From: Singh, Sumeet
Sent: 11/12/2013 3:54:58 AM
To: Shori, Sunil (sunil.shori@cpuc.ca.gov)
Cc: Yura, Jane (/O=PG&E/OU=CORPORATE/CN=RECIPIENTS/CN=JKY1); Redacted
Redacted Doll, Laura (/O=PG&E/OU=CORPORATE/CN=RECIPIENTS/CN=LRDD)
Bcc:
Subject: RE: Line 147 Follow-up Items (Week of October 28, 2013)

From: Singh, Sumeet
Sent: Saturday, November 02, 2013 12:33 PM
To: 'sunil.shori@cpuc.ca.gov'
Cc: Yura, Jane; Doll, Laura; Redacted
Subject: Line 147 Follow-up Items (Week of October 28, 2013)

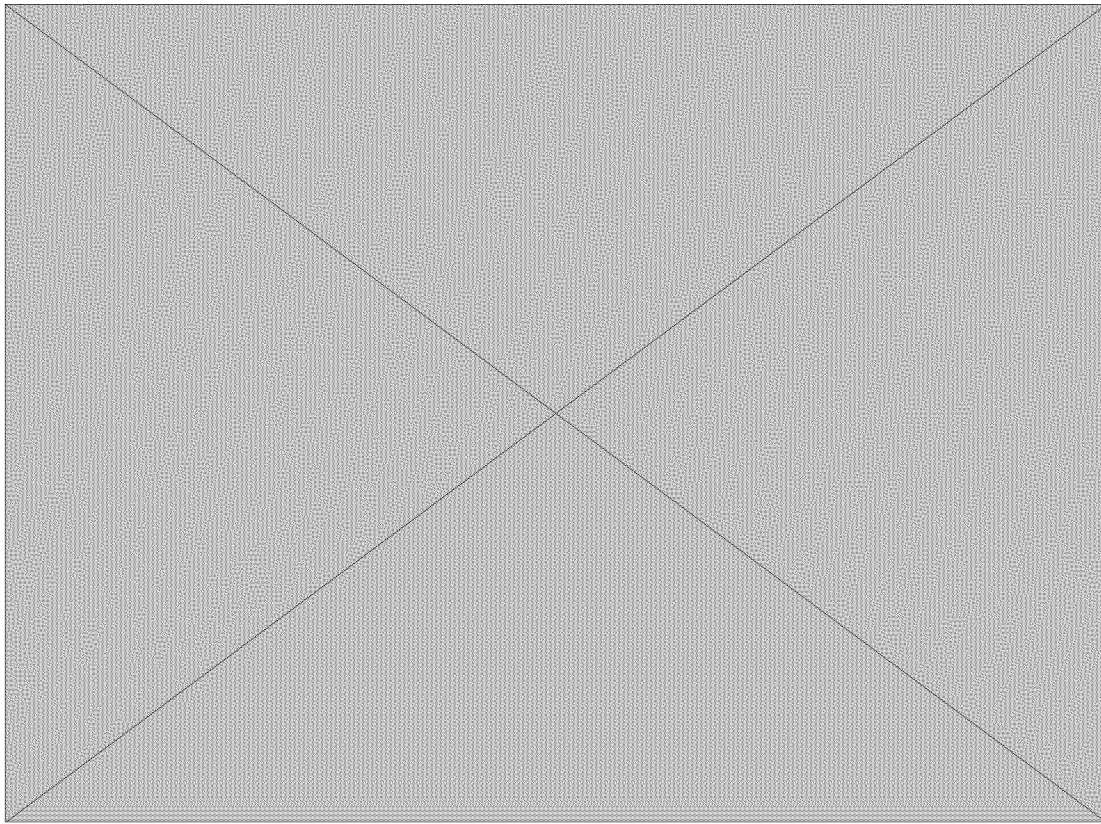
1. Excavation at [Redacted] - Complete

Pipe characterization associated with this excavation was completed today and was verified to

be consistent with the PFL consisting of 20" OD x 0.281" WT and Seamless pipe. I will provide you with both the 2004 H-form, underlying specification records and the H-form from this week's dig by tomorrow. Please note that the complete H-form from the excavation will be available by middle of next week but we will provide you with a version by tomorrow that includes the pipe specifications.

5. Regulator Station B43 Redacted **- Complete**

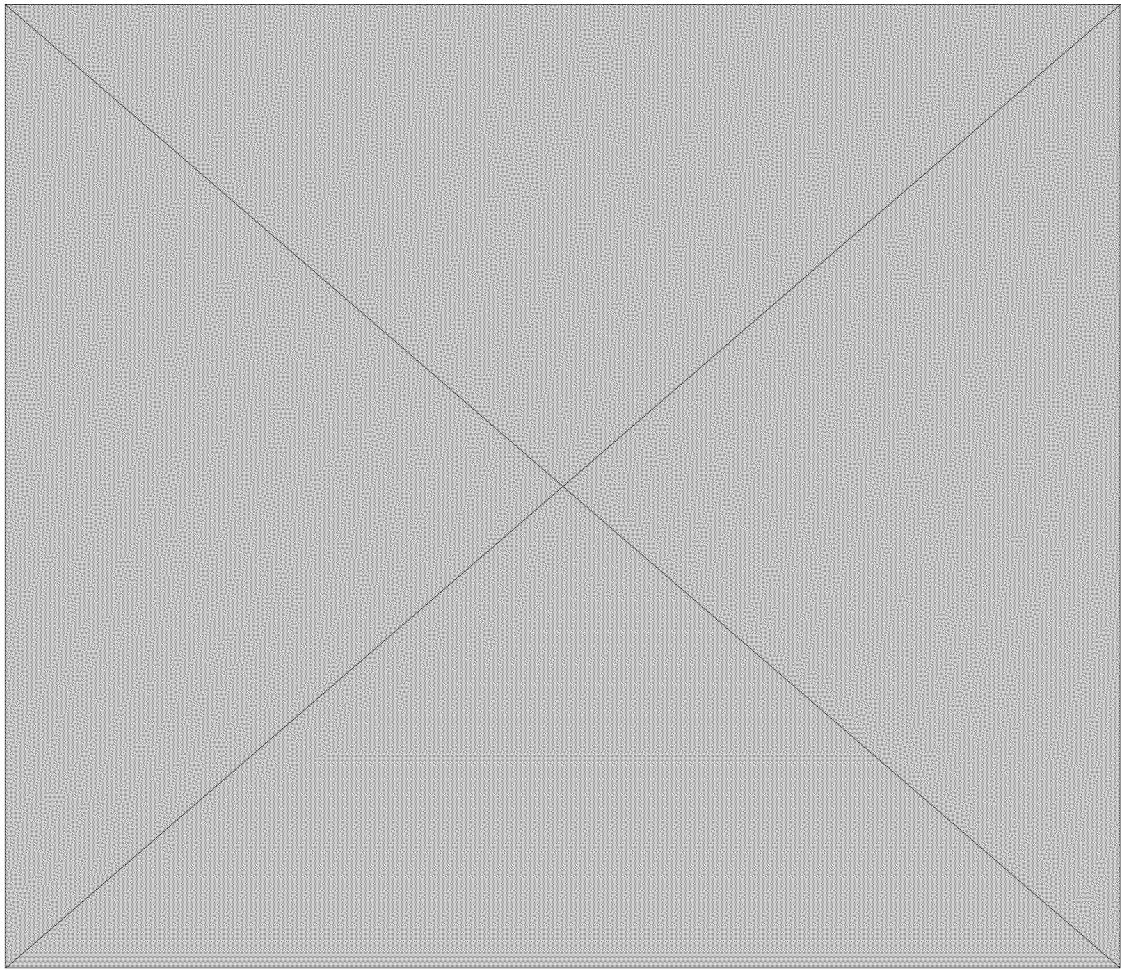
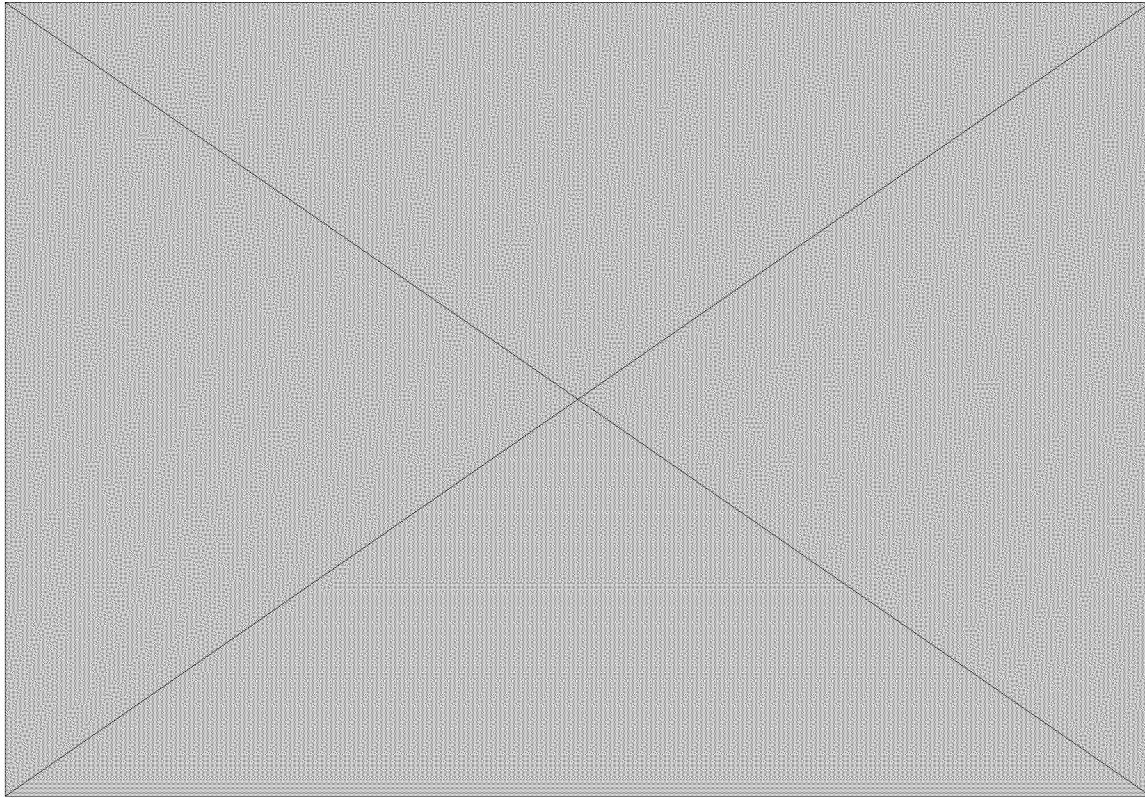
Based on your site visit, you identified an aboveground district regulator station susceptible to potential vandalism as the valves were not locked and there was no fence around the station. Based on a follow-up site visit performed by our field technicians, we installed locks on all valves on 11/1 and a temporary fencing will be installed on 11/4. The installation of permanent fencing will require permitting from various environmental agencies; hence, taking significantly longer to implement which we will continue to pursue. I will provide you with the associated documentation as it becomes available.

Please refer to the attached pictures below.

10/25

11/1
